1 OLD CONNA WASTE WATER PUMPING STATION

Purpose		FOR PLANNING			
Title		PROPOSED PUMP STATION & EMERGENCY 24hr STORAGE TANK SITE LAYOUT PLAN			
Original Scale	Drawn	Checked	Reviewed	Authorised	
1:200 at A1	PM	PS	PS	GH	
1:400 at A3	Date 31.09.26	Date 31.09.26	Date 31.09.26	Date 31.09.26	
Status	Drawing Number				Rev
S4	ATK-ZZ-ZZ-DR-CE-900572				P02

Irish Water Form IW-AD-EDS-FM-003			Project Design Review Contract Document and Comments Tracker		
Workshop Date:					
			WS4		
			IDD Portfolio Manager		
			ESP Feedback / Comments		
Document	Participant Name	Query ID	IW Observations / Comment	ESP Feedback / Comments	Addressed by
Planning WWPS and RM Design Report - Phase A1	Padraig Hanly	ADRL 4.1	Section 2.2 of Report - Masterplan comments sent back by UE for response. WS4 Detailed Design and WS 5 Hazop to occur later when the detailed design for the project is complete.	Noted	AtkinsRéalis
Planning WWPS and RM Design Report - Phase A1	Padraig Hanly	ADRL 4.2	Section 2.2 of report - Mentioned that character areas may change later as development plans progress. The levels of the WWPS are now being set through the review and acceptance of the masterplan and proposed WWPS inlet levels. If

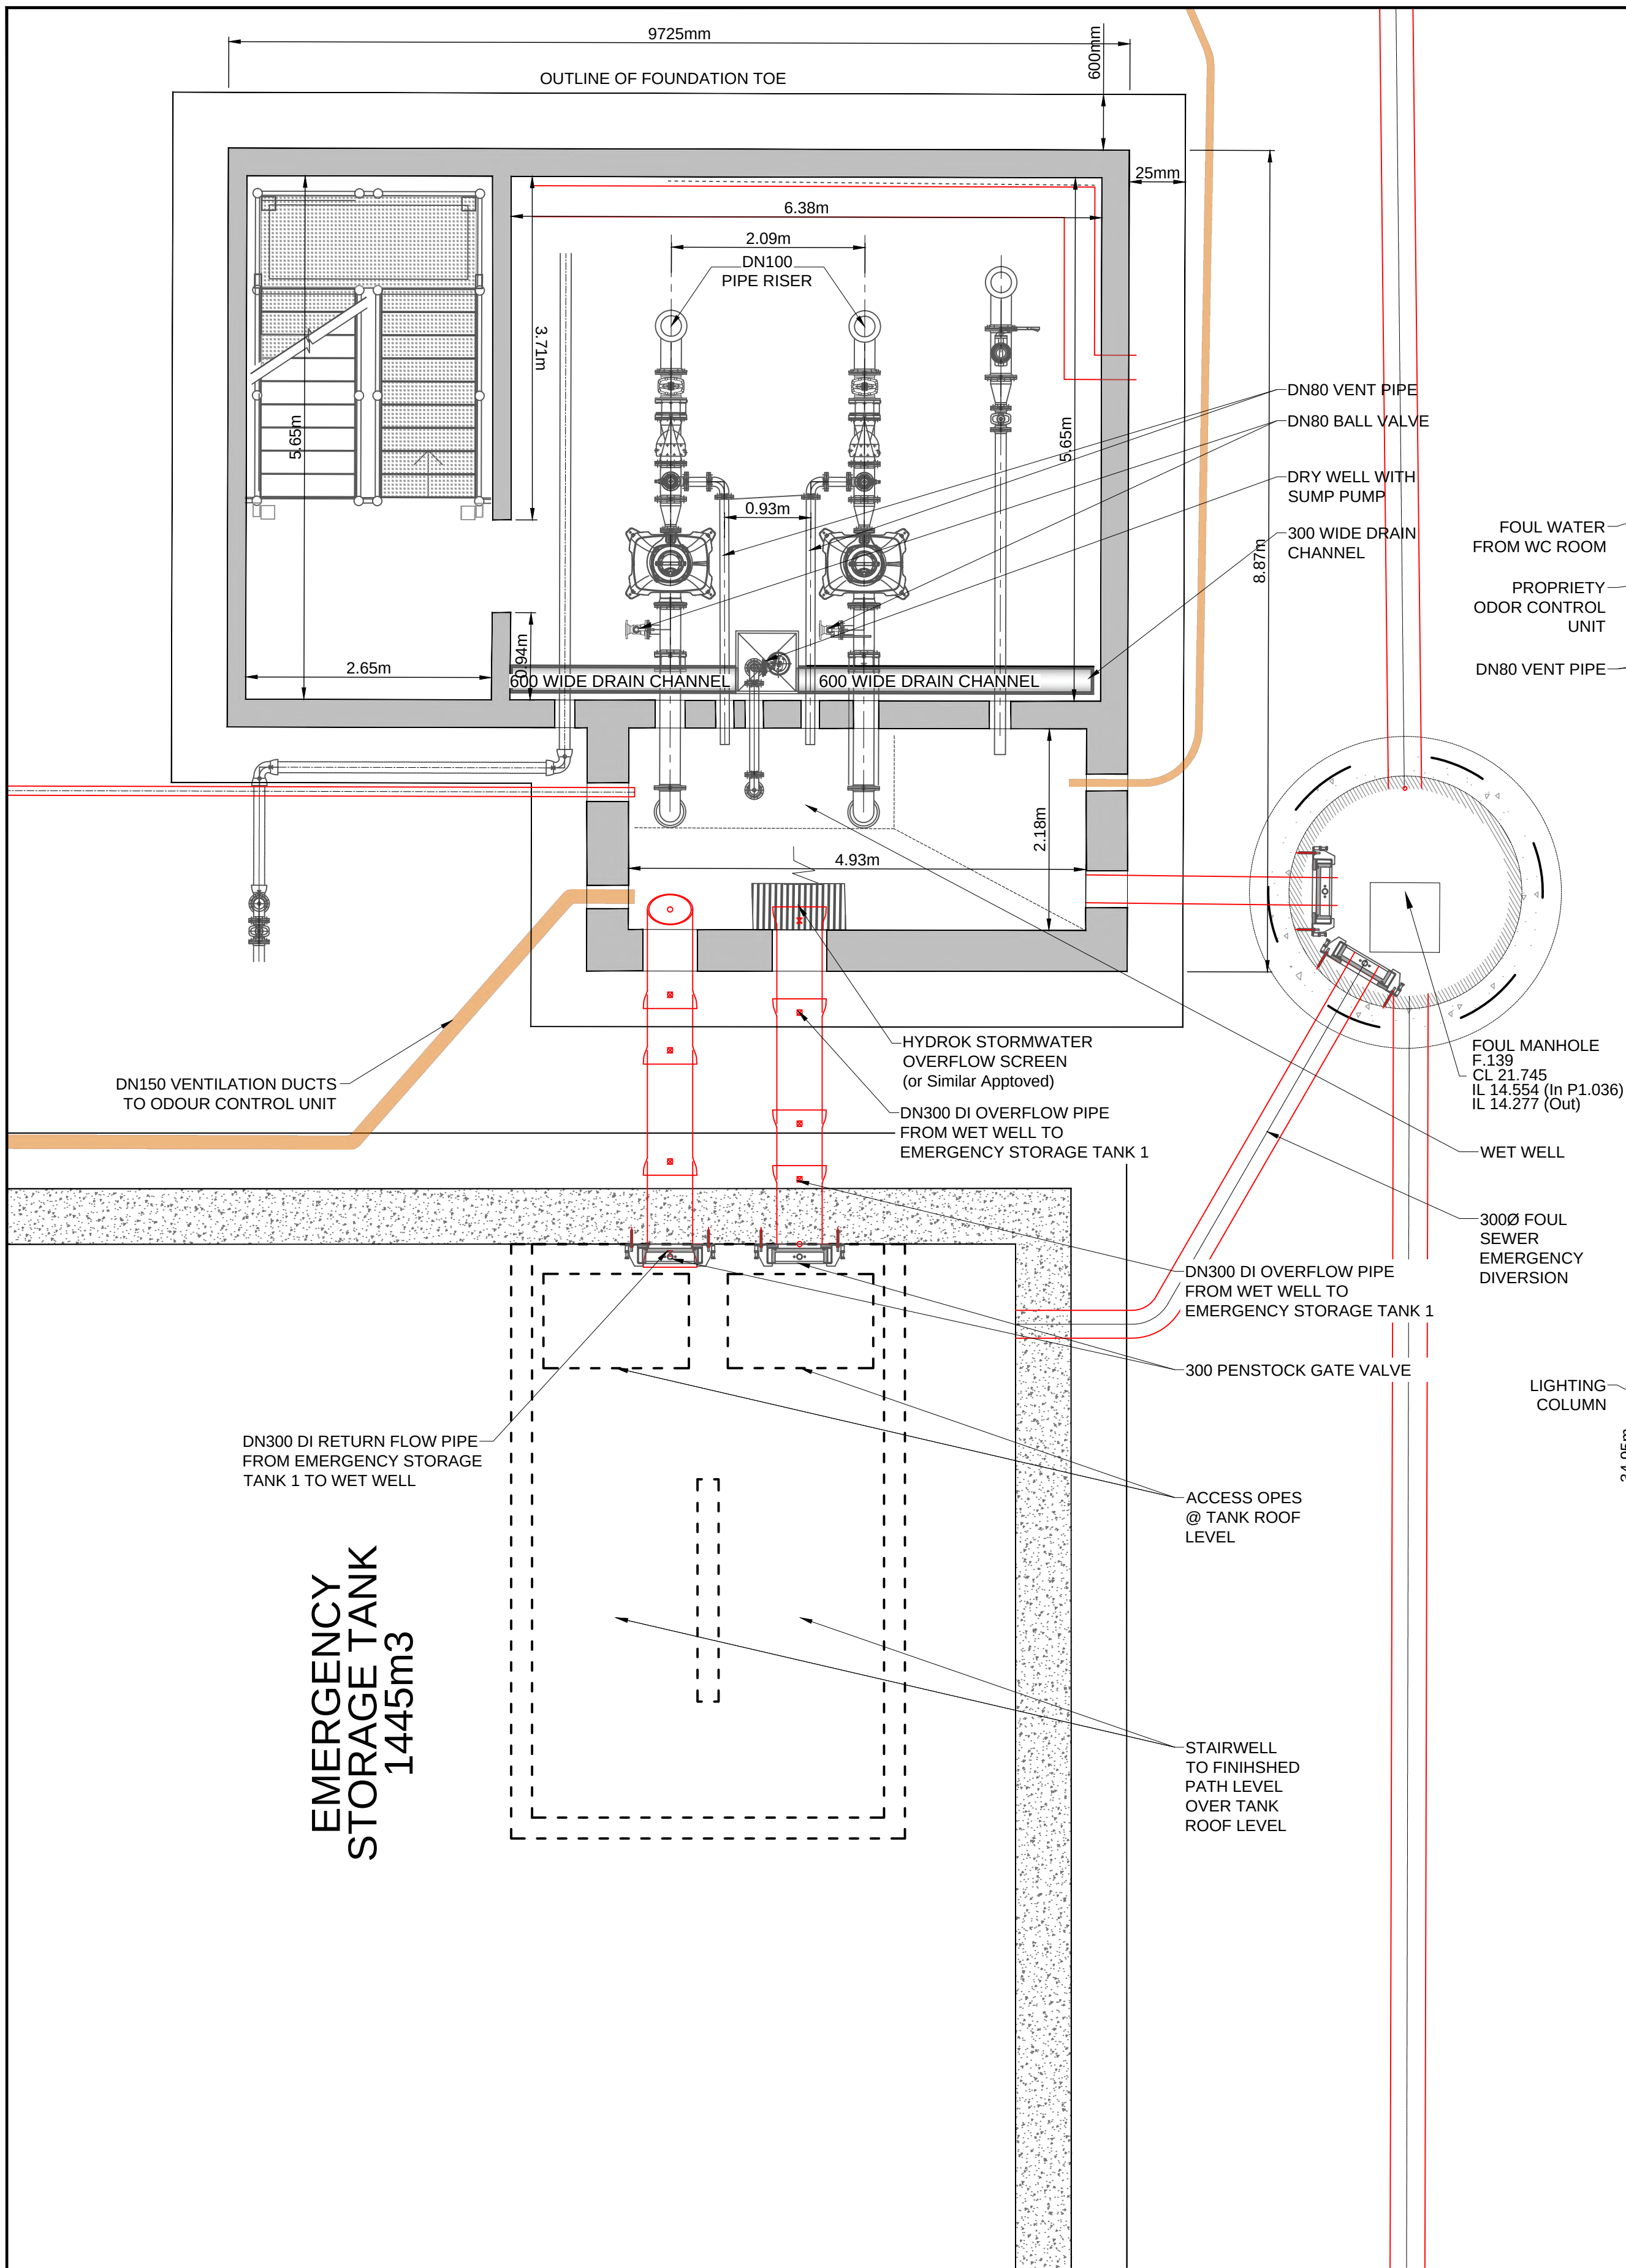
Planning WWPS and RM Design Report - Phase A1	Padraig Hanly	ADRL 4.6	Site Layout Drawing - Important that the sizing etc of above ground structures is conservative to ensure there is no need to make anything bigger after planning has been submitted	Engagement with the landowners to the West of the N11 has taken place. To the East of the N11 no engagement has taken place, however, the proposed HDD receiver pit and associated vent stack is located with public areas or areas in charge of DL RCC	AtkinsRéalis
Planning WWPS and RM Design Report - Phase A1	Padraig Hanly	ADRL 4.7	Are welfare facilities required by Ops? I.e. toilet etc. Is a control building required for a WWPS of this scale rather than kiosks?	Refer to AtkinsRealis drawing ATK-ZZ-ZZ-DR-CE-900572 for pump station layout and associated drawings including plan and elevations of proposed equipment and buildings.	AtkinsRéalis
Planning WWPS and RM Design Report - Phase A1	Padraig Hanly	ADRL 4.8	Proposed Storage Tank Cross Section Dwg - this shows the tank close to existing ground level. It is understood the pipe inlet invert level is approx 7m deep. Cross sections to be updated accordingly.	A welfare facility has been provided as part of the proposed Pump Station Building. Refer to AtkinsRealis drawing ATK-ZZ-ZZ-DR-CE-900574 for building layout.	AtkinsRéalis

Planning WWPS and RM Design Report - Phase A1	Padraig Hanly	ADRL 4.9	As per Operations comments elsewhere, for WWPS of this depth typically Dry Well arrangement required. This needs to be accommodated in WWPS design before planning submission as it will impact site footprint, layout etc.	Refer to AtkinsRealis drawing ATK-ZZ-ZZ-DR-CE-900575 and ATK-ZZ-ZZ-DR-CE-900576 for cross sections through the proposed tank.	AtkinsRéalis
Planning WWPS and RM Design Report - Phase A1	Padraig Hanly	ADRL 4.10	Positioning of gantry etc (if needed) to be included in planning drawings as they are above ground	Design has been updated for Dry Well arrangement.	AtkinsRéalis
Planning WWPS and RM Design Report - Phase A1	Padraig Hanly	ADRL 4.11	Are jet mixers or blowers required here for this tank? Blowers require above ground kiosks which will impact planning drawings. Blowers have been required on a similar project with storage tank of this depth	Design has been updated for Dry Well arrangement. Based on the depth of the tank blowers have been provided with above ground kiosks. Refer to AtkinsRealis drawing ATK-ZZ-ZZ-DR-CE-900572	AtkinsRéalis

Planning WWPS and RM Design Report - Phase A1	Atkins (UE)	ADES 4.28	A bypass connection with penstock arrangement shall be considered from inlet manhole to emergency storage tank - no such details available.	Provided, please refer to AtkinsRéalis drawing ATK-ZZ-ZZ-DR-CE-900572 for further details.	AtkinsRéalis
Planning WWPS and RM Design Report - Phase A1	Atkins (UE)	ADES 4.29	Inadequate details for Odour control unit, lighting arrangement, fencing, security gate, access road, surface water drainage, welfare facility, wash down	Please refer to AtkinsRéalis drawings ATK-ZZ-ZZ-DR-CE-900572 - ATK-ZZ-ZZ-DR-CE-900580 for further details including OCU. Lighting, fencing, gates, access road, drainage, welfare facility, Pump Station Building, emergency wash down etc.	AtkinsRéalis
Planning WWPS and RM Design Report - Phase A1	Atkins (UE)	ADES 4.30	What is the height of the vent stack? the height shall be clearly indicated - also the PS layout drawing does not show the vent stack	An Active OCU has been provided as part of the Dry Well design. Please refer to drawing AtkinsRéalis drawing ATK-ZZ-ZZ-DR-CE-900572 for further details.	AtkinsRéalis

Planning WWPS and RM Design Report - Phase A1	Atkins (UE)	ADES 4.31	The sewer connection from south is not showing in the drawing - include most updated drawing	Please refer to drawing AtkinsRéalis drawing ATK-ZZ-ZZ-DR-CE-900572 for further details. Connection will terminate outside of the proposal PS fence line to allow for future connections by others.	AtkinsRéalis
Planning WWPS and RM Design Report - Phase A1	Atkins (UE)	ADES 4.32	Access road width, finish, long and cross sections with adequate details are not included	The proposed access road will be 6m wide as indicated on drawing ATK-ZZ-ZZ-DR-CE-900572 . Refer to AtkinsRéalis typical road cross sections within the planning application for build up.	AtkinsRéalis
Planning WWPS and RM Design Report - Phase A1	Atkins (UE)	ADES 4.33	There are close proximity found with existing Tress around the Ps area and also along the rising main. Please include a biodiversity calculation showing net gain through adequate landscape planning. Also the excavation works shall consider adequate exclusion zone as per UE standards	Refer to overall planning application package for Environmental consideration as part of the wider development including Pump Station.	AtkinsRéalis

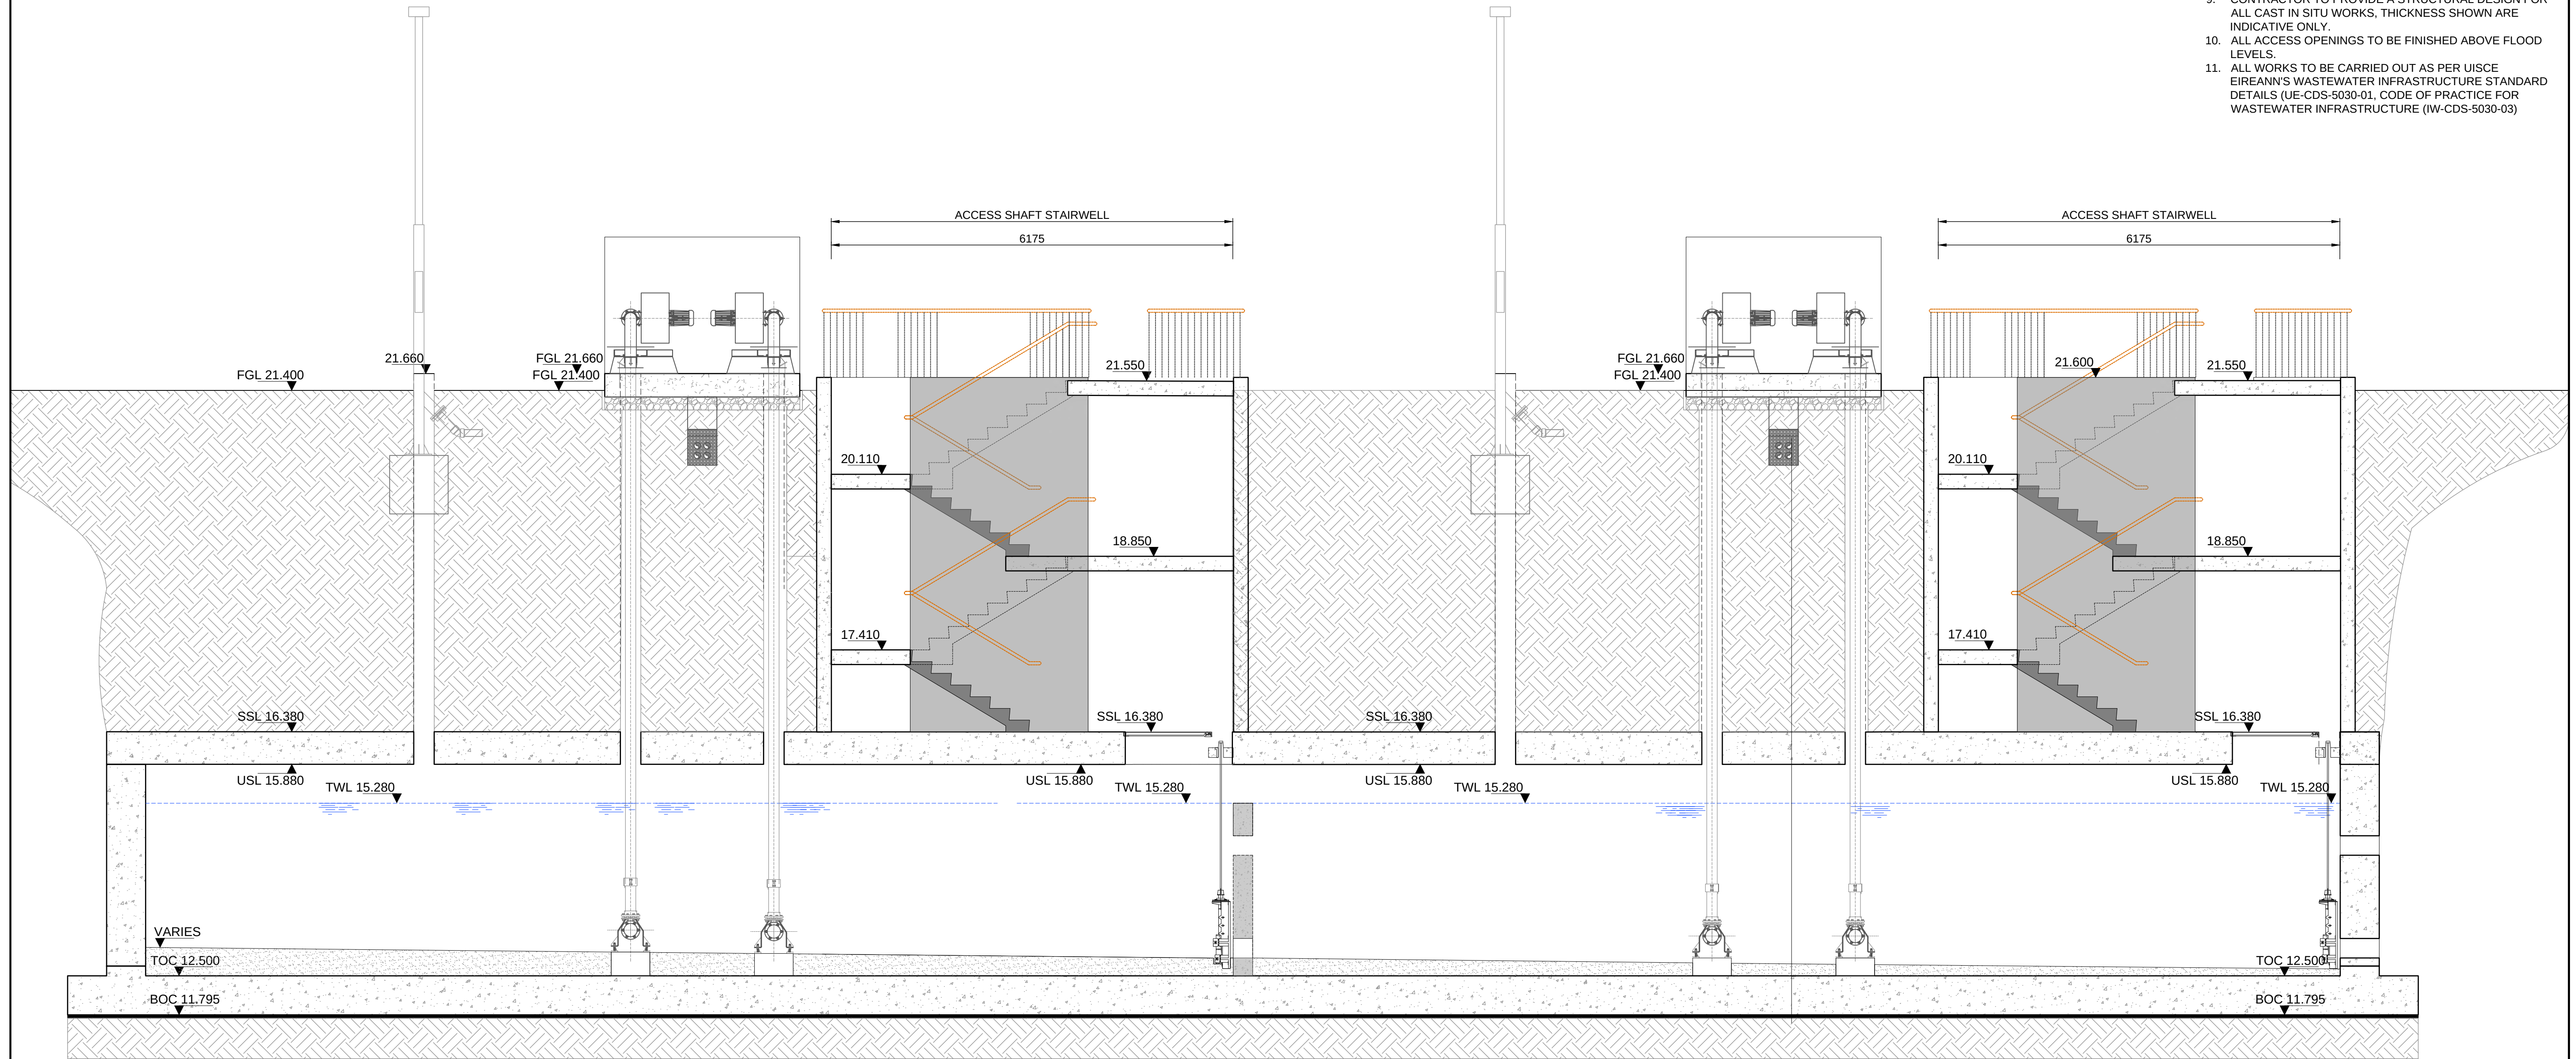
Planning WWPS and RM Design Report - Phase A1	Atkins (UE)	ADES 4.12	Was 2 cells over 1 big Emergency storage tank considered from cleaning and maintenance perspective as it will have - less pipe work, fewer valves and better hydraulic characteristic	The proposed Emergency storage tank has been split into 2 cells as advised rather than 1 large tank. Refer to AtkinsRealis drawing ATK-ZZ-ZZ-DR-CE-900572 and ATK-ZZ-ZZ-DR-CE-900575 for plans and cross section.	AtkinsRéalis
Planning WWPS and RM Design Report - Phase A1	Atkins (UE)	ADES 4.13	Manhole 2050x1500 - Please indicate what this is for? Is it an access shaft?	Layout has been updated, refer to AtkinsRealis drawing ATK-ZZ-ZZ-DR-CE-900572	AtkinsRéalis
Planning WWPS and RM Design Report - Phase A1	Atkins (UE)	ADES 4.14	Over pump Bauer connection has not been considered	Design has been revised to a Dry Well pump Station.	AtkinsRéalis
Planning WWPS and RM Design Report - Phase A1	Atkins (UE)	ADES 4.15	It is assumed that the rising main has been routed beneath the chemical bulk tank and dosing kiosk to avoid increasing the overall pumping station footprint, particularly given that the chemical dosing system is intended for interim operation only. However, depending on the anticipated duration of the interim phase, it would be prudent to confirm that the arrangement remains acceptable from an operational and maintenance perspective, as any future requirement for inspection, repair or replacement of the rising main could present access and operational challenges	Layout has been updated with chemical Dosing Units not directly above the rising main. Chemical dosing unit now connected directly into Wet well. Depending on Phasing of the Old Conna LAP and construction stages it will be determine at what stage dosing is required until sufficient PE where dosing can be removed. Further discussions to take place at detail design stage with UE in relation to operational and maintenance requirements.	AtkinsRéalis

Planning WWPS and RM Design Report - Phase A1	Atkins (UE)	ADES 4.22	Permanent lifting arrangement is required as per UE standard - no details has been shown	Design has been revised to a Dry Well pump Station.	AtkinsRéalis
Planning WWPS and RM Design Report - Phase A1	Atkins (UE)	ADES 4.23	The mixing arrangement for the emergency storage tank has not been indicated. In addition, Tank cleaning provisions should be incorporated, taking into account the storage tank capacity and the recommended operational and maintenance requirements.	Tank Mixers have been provided with overground blower kiosk as indicated on AtkinsRéalis drawing ATK-ZZ-ZZ-DR-CE-90072 . Tank has been split into 2 cells reducing the need for cleaning of a single large tank. Full details of cleaning requirements will be provided to UE at detail design stage and agreed prior to construction.	AtkinsRéalis
Planning WWPS and RM Design Report - Phase A1	Atkins (UE)	ADES 4.24	The return discharge from the emergency storage tank is approximately 2.65 m above the wet well floor. Please ensure that adequate energy dissipation measures are incorporated to prevent turbulence and vortex formation at the pump suction. However, in light of the comments noted above, the overall emergency storage tank levels should be reviewed and finalised to ensure satisfactory hydraulic performance.	Design has been revised to a Dry Well pump Station. Return from Emergency storage tank has been revised to a depth of circa 600mm.	AtkinsRéalis
